Quad Cities Nuclear Power Station, Unit 2  
Renewed Facility Operating License No. DPR-30  
NRC Docket No. 50-265

Subject: Additional Information Supporting Reactor Pressure Vessel Penetration N-11B  
Repair Relief Request I5R-11

Attachment: 10 CFR 50.55a Relief Request I5R-11, Revision 3

Figure 1

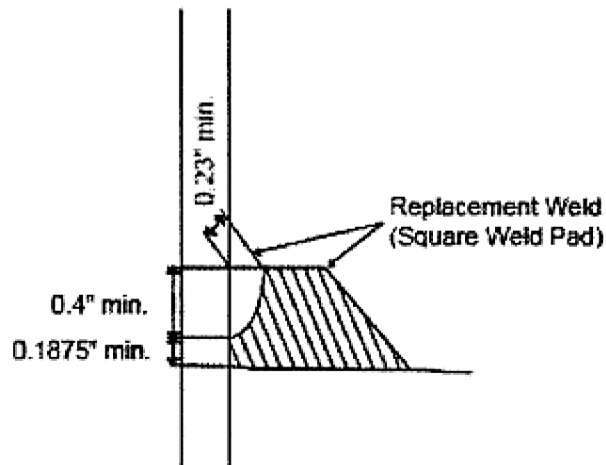
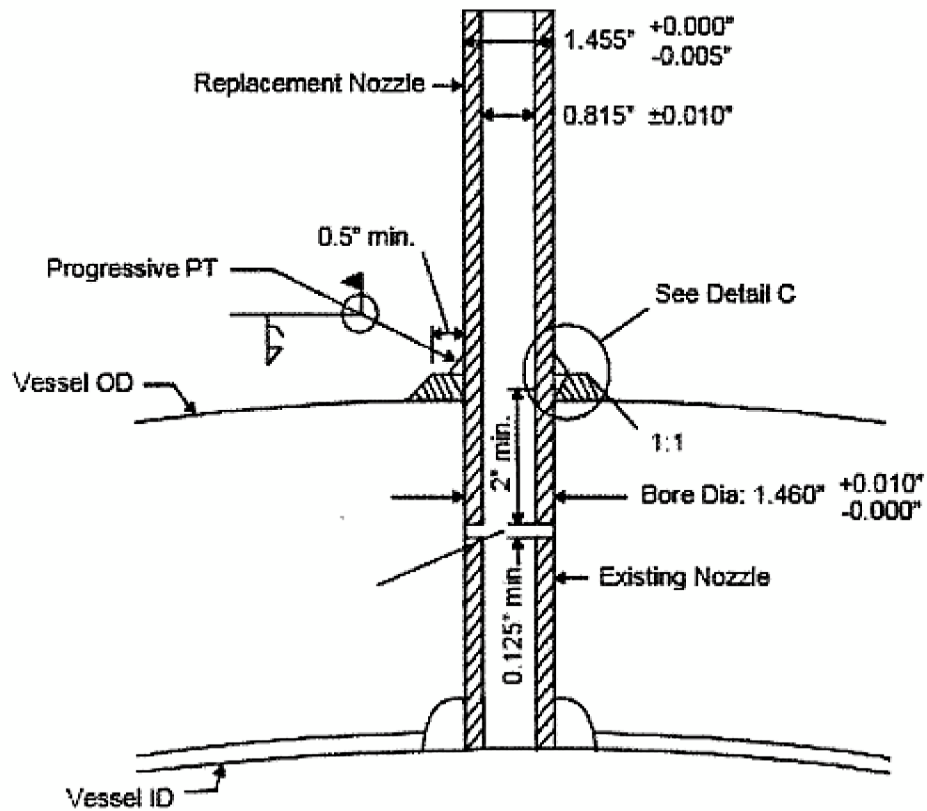
Please revise Relief Request I5R-11, Revision 2, to reflect a duration supported by the flaw evaluation (e.g., 9 years beyond the date when the NDE technique was performed in 2016) or provide justification to demonstrate that a longer interval can be technically supported without relying on future unknown NDE results.

In response to this request, EGC is revising relief request I5R-11 to reflect that the duration of the proposed alternative is 9 years beyond the date when the NDE technique was performed in 2016. The revised relief request is provided in the Attachment.

EGC replaced the existing nozzle assembly with a nozzle penetration that is resistant to IGSCC, meeting Section XI and Code Case N-638-4 as conditionally approved by the NRC in Regulatory Guide 1.147, Revision 17. Figure 1 provides a diagram of a typical RPV water level instrument nozzle repair. A welded pad was applied to the OD of the RPV using IGSCC resistant nickel Alloy 52M (ERNiCrFe-7 or -7A) filler metals and was welded using the machine GTAW ATTB welding technique. The IGSCC resistant nozzle was attached to the new weld pad with a partial penetration weld using a non-temper bead manual welding technique. The original partial penetration attachment weld and a remnant of the original nozzle currently remain in the RPV, and will continue to remain, in place. A weld flaw evaluation, described below, was completed to demonstrate the acceptability of leaving the original partial penetration attachment weld in service.
